August 2014 | Final Environmental Impact Report and Response to Comments

HARBOR BOULEVARD MIXED USE TRANSIT CORRIDOR PLAN

for City of Santa Ana

Exhibit 4.1 - Existing Year 2013 Intersection Geometry *Harbor & Cardinal?*

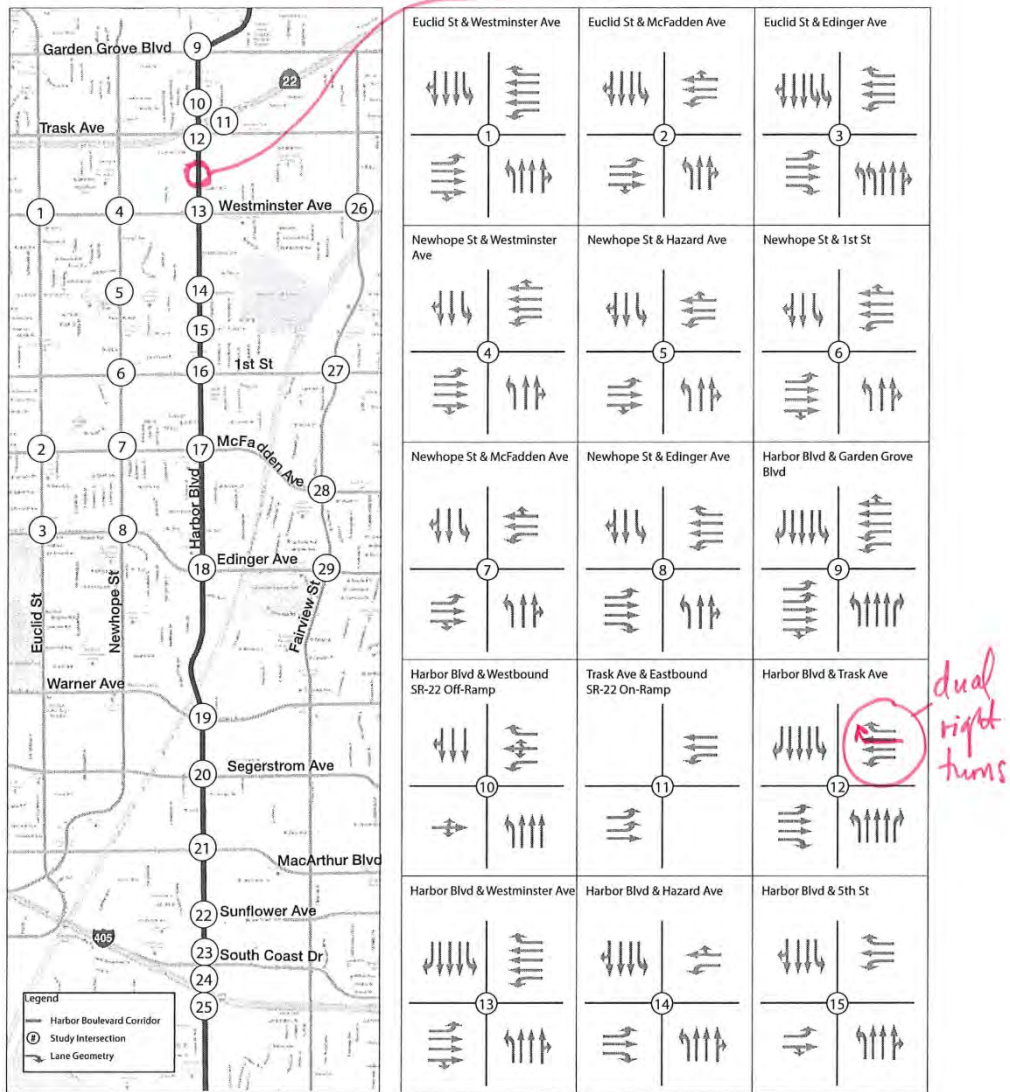
1. Please provide information as to why the signalized intersection of Harbor and Cardinal which is between Westminster and Trask was not included in the study.
2. The intersection geometry of Harbor and Trask is not correct. We currently have dual right turns, one single thru lane, and one left turn lane for westbound Trask at Harbor.

A2-1 The traffic impact analysis included the assessment of signalized intersections along Harbor Boulevard within the boundaries of the Specific Plan and the adjacent arterial street to arterial street intersections along east-west corridors that pass through the Specific Plan boundaries. Beyond the Specific Plan boundaries on Harbor Blvd, the primary distribution of traffic is north-south along Harbor Boulevard. Therefore, the analysis focuses on traffic conditions at intersections of Harbor Blvd and cross-streets that are designed as Primary Arterials or higher. Higher numbers of turning movements were not forecast at minor streets such as Cardinal (classified as a local street).

At the intersection of Harbor and Cardinal, the through volumes on Harbor for the 2035 with project conditions are generally forecast to be lower than the no project condition, based on the changes to trip generation and trip distribution with the proposed change in land use. Therefore, no new significant impacts are anticipated.
